Cumberland County Subdivision and Land Development Review Report

Municipality: Camp Hill Surveyor/ Engineer: K&W Engineers, LLC Owner/ Developer: Camp Hill School District

Plat Title: Additions and Renovations to Hoover El. School

Plat Status: Preliminary/Final Plat Type: Land Development

PLAN TYPE: **DEMOLITION PLAN**

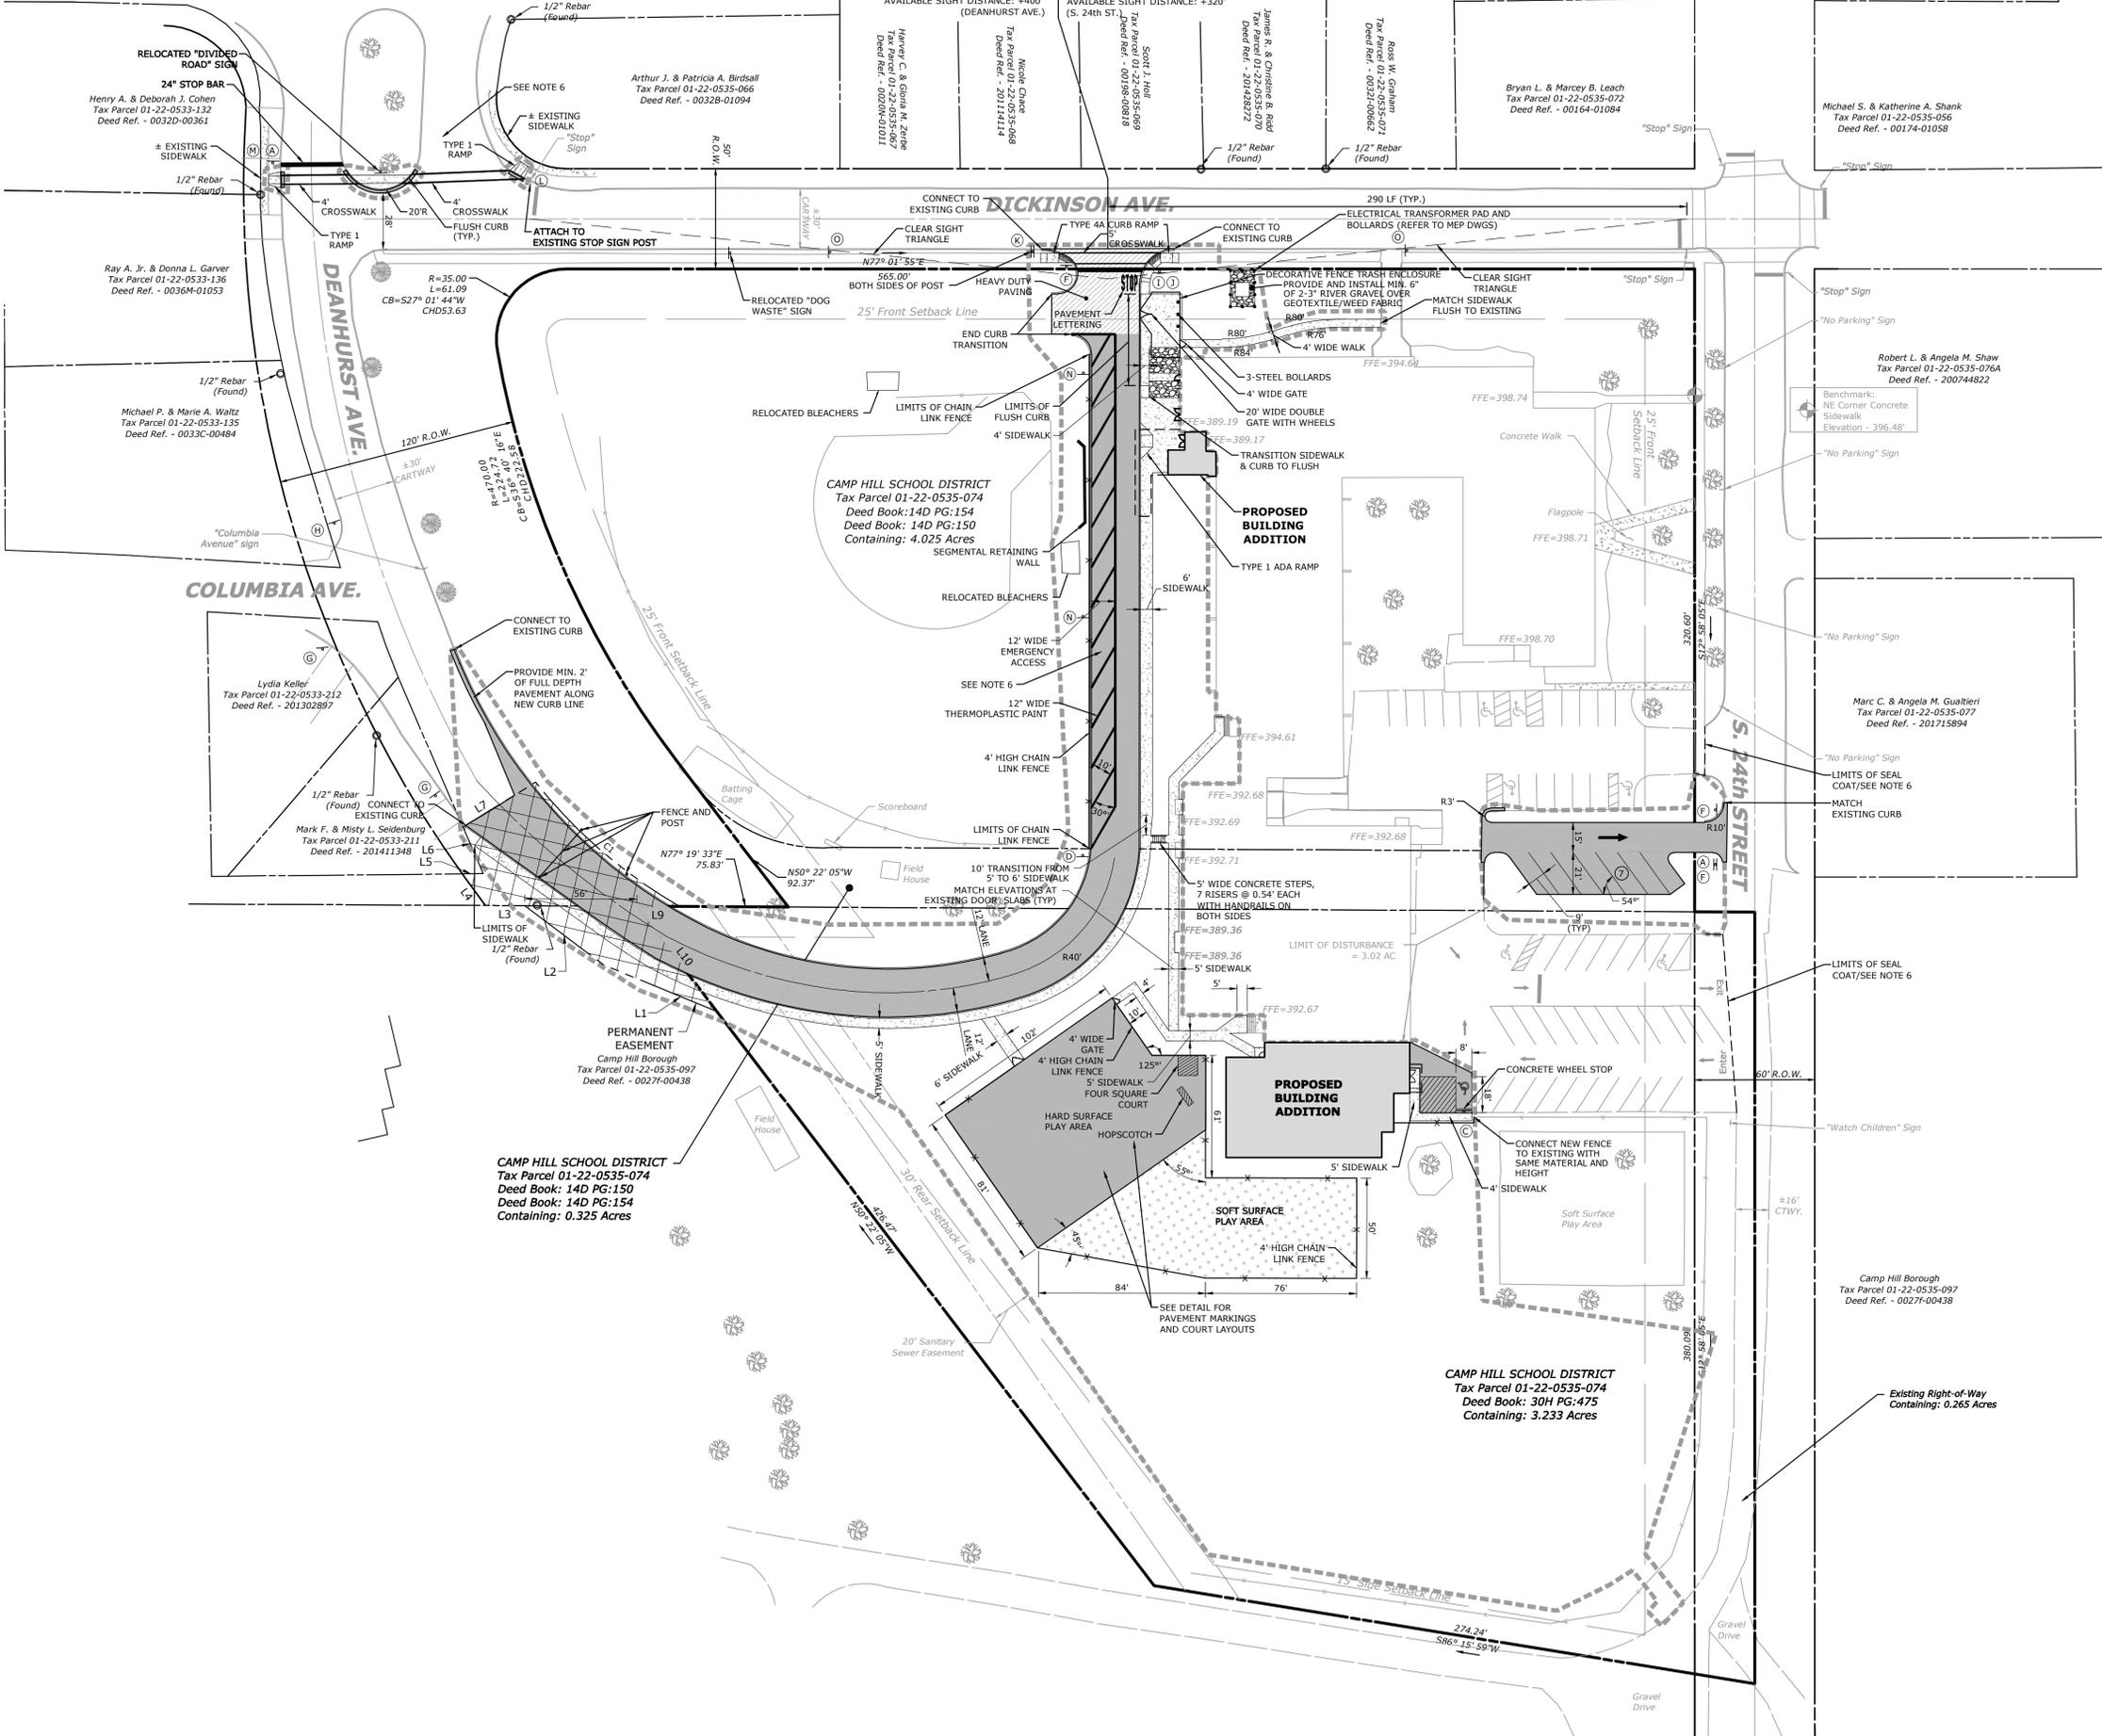
4. The Borough should consider requiring a sidewalk along South 24th Street. The Demolition Plan indicates that a sidewalk that is being demolished and not replaced.

Table with 2 columns: REVISIONS (NO., DATE, DESCRIPTION) and PLAN TYPE (SITE PLAN)

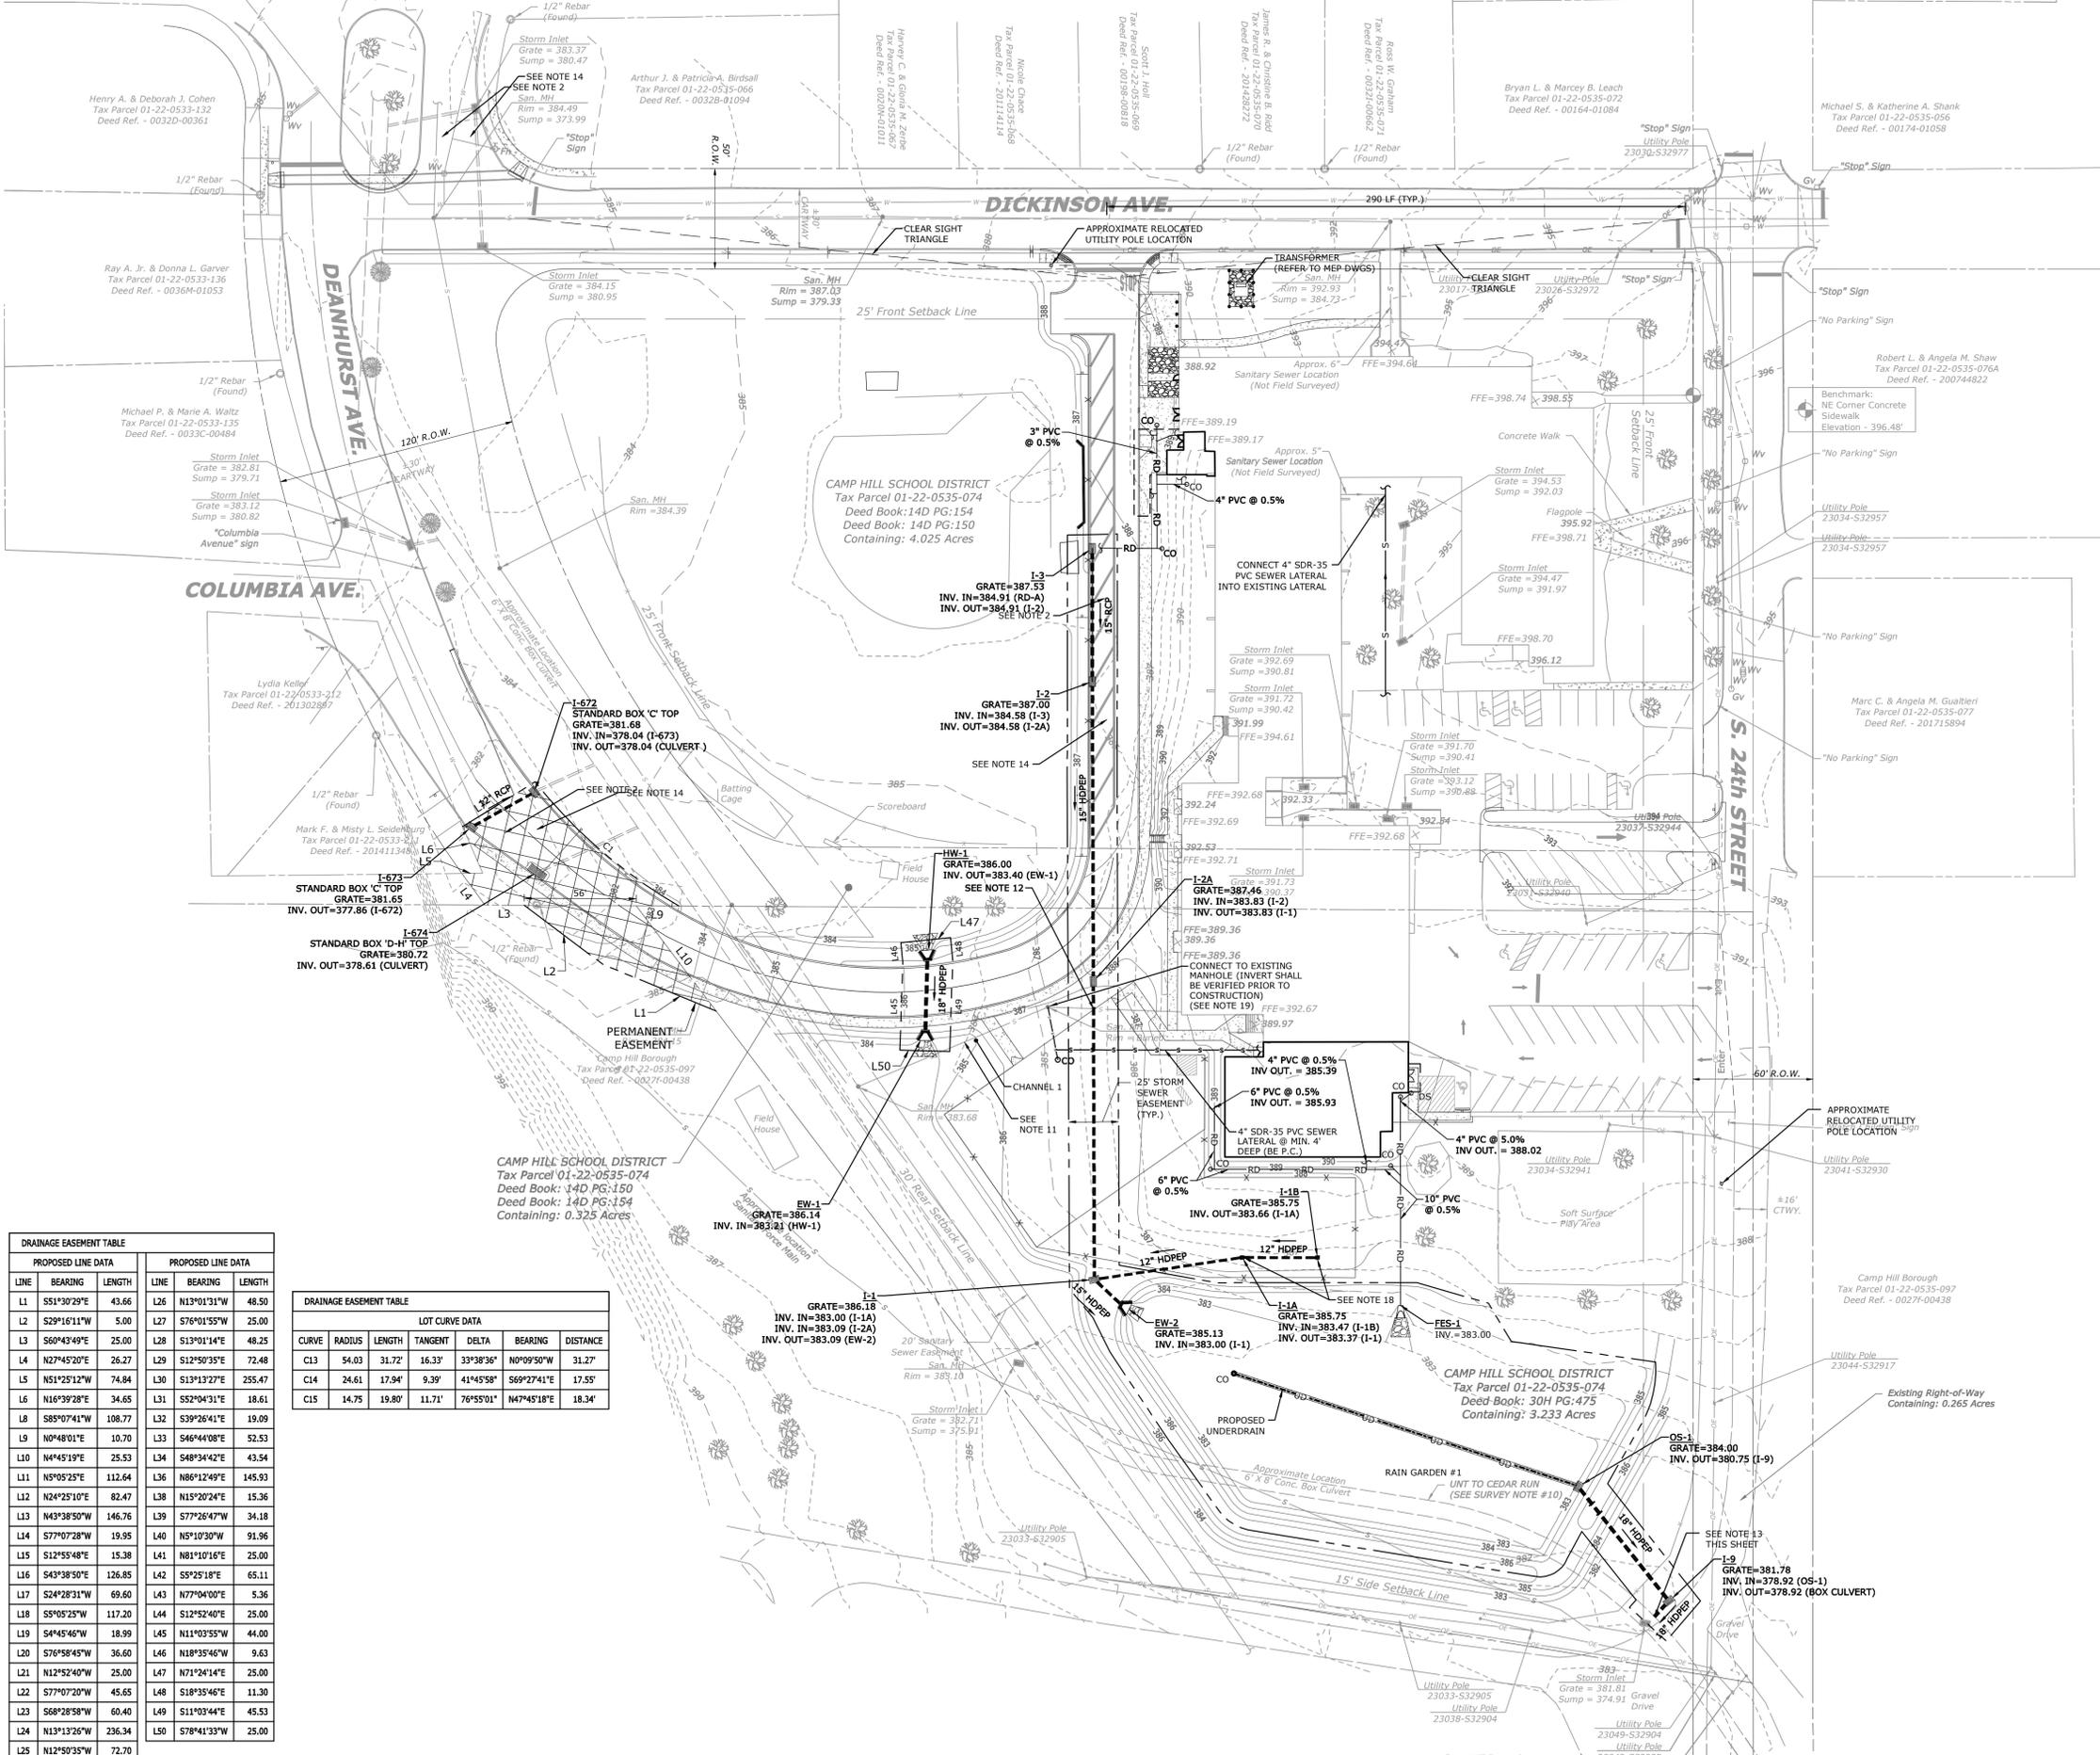
1. The Permanent Easement shown on Deanhurst Avenue should include a description of the easement and an instrument number (SLDO 405.1.A.14).
2. The Applicant and the Borough should clarify the flow of traffic and signage on Deanhurst Avenue. The following issues should be reviewed:

- a. It appears that the road will be a one-way road. If this is the case, directional arrows should be provided.
 - b. The Applicant is proposing a “Fence and Post” across Deanhurst Avenue. The plan should include turnaround areas for vehicles. Will this fence and post be opened for student drop-off?

- c. Will student drop-off and pickup occur on Deanhurst Avenue? This should be reviewed for safety concerns. It appears that the 12-foot emergency access may inadvertently be used to drop off students which may create emergency service concerns. Recommend the drop-off and pick-up area be designed so students do not have to cross the street.

- d. The plan should be reviewed by emergency service providers and utility providers. Will the proposed layout permit trash collection and adequate emergency service?

- e. Crosswalks should be provided where pedestrians access the baseball field, field house, batting cage, and relocated bleachers.
 - f. Traffic calming measures along Deanhurst Avenue should be considered.

- g. The proposed sidewalk should connect to the existing sidewalk at 500 Deanhurst Avenue.

- h. Sign “T” indicates that all traffic must turn left. What is the purpose of this limitation at the intersection with Dickinson Avenue? If applicable, the intersection should be reconfigured to encourage left turns only.

3. The proposed access and parking spaces off of South 24th Street should be reviewed for safety. It appears that there will be 4 proposed access points in close proximity.
